# Work Order ID 61842

C	ADD -049/-051/-053, CHANGE DRAWING FORMAT	PH	07.10.05
B	ADD -047; UPDATE DIM A FOR -045	PH	06.05.11
A	NEW ISSUE	PH	06.01.04
REV.	DESCRIPTION	BY	DATE
DESIGN	<i>PH</i>	<b>DART AEROSPACE LTD</b> HAWKESBURY, ONTARIO, CANADA DRAWING NO. <b>D3492</b> TITLE <b>PLUG</b> SCALE 2:1 REV. C SHEET 1 OF 2 COPYRIGHT © 2007 BY DART AEROSPACE LTD THIS DOCUMENT IS PRIVATE AND CONFIDENTIAL AND IS SUPPLIED ON THE EXPRESS CONDITION THAT IT IS NOT TO BE USED FOR ANY PURPOSE OR COMMUNICATED TO ANY OTHER PERSON WITHOUT WRITTEN PERMISSION FROM DART AEROSPACE LTD.	
DRAWN	<i>PH</i>		
CHECKED	<i>PH</i>		
MFG. APPR.	<i>PH</i>		
APPROVED	<i>PH</i>		
DE APPR.	<i>PH</i>		
DATE	07.10.05

DRAWING NO. D3492	TITLE PLUG	REV. C	DART AEROSPACE LTD ENGINEERING ORDER		D.E.O. NO. D3492-C-1	SHEET NO. SHEET 1 OF 1	SCALE NTS
DRAWN AJS	CHECKED	MFG. APPR. <i>B</i>	APPROVED <i>W</i>		DE APPR. <i>W</i>		
DATE 08.11.05	DATE 08.11.05	DATE 08.11.05	DATE 08/11/05		DATE 08/11/05

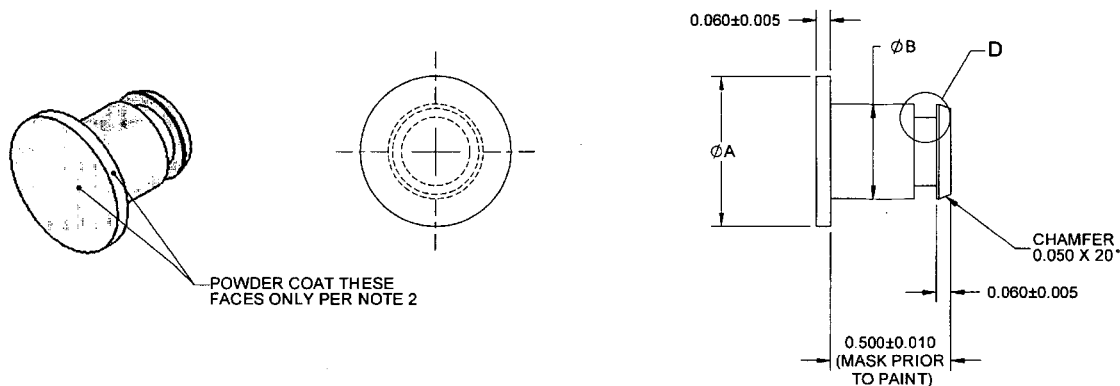
DEM. B ON D3492-7

REF. C (MAKE SMALLER)

OKay
